## Modular Roof System page 1

## Modular Roof System page 2

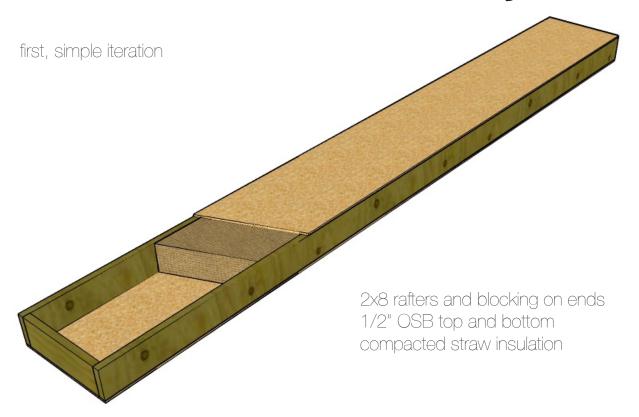
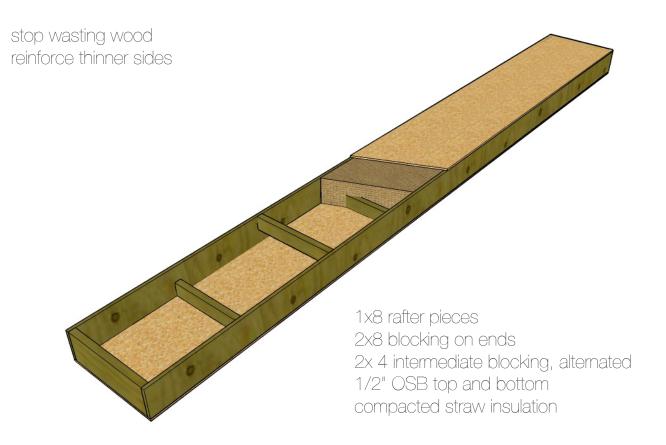
doubling 2x8s when coupled watses wood nearly twice as many rafters as required

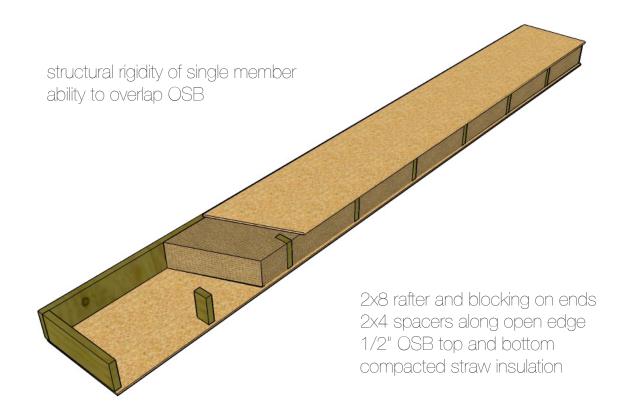
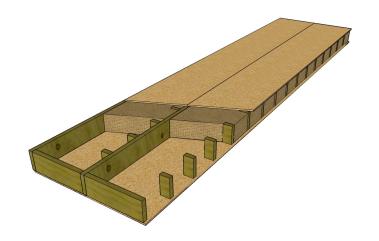
no way to effectively nail 1x8s together will 1x8s be sufficient if not attached? (maybe, 2x4 blocking stiffens)

no way to overlap OSB unrealistic to ask volunteer carpenters to overlap something 3/8" along 16'
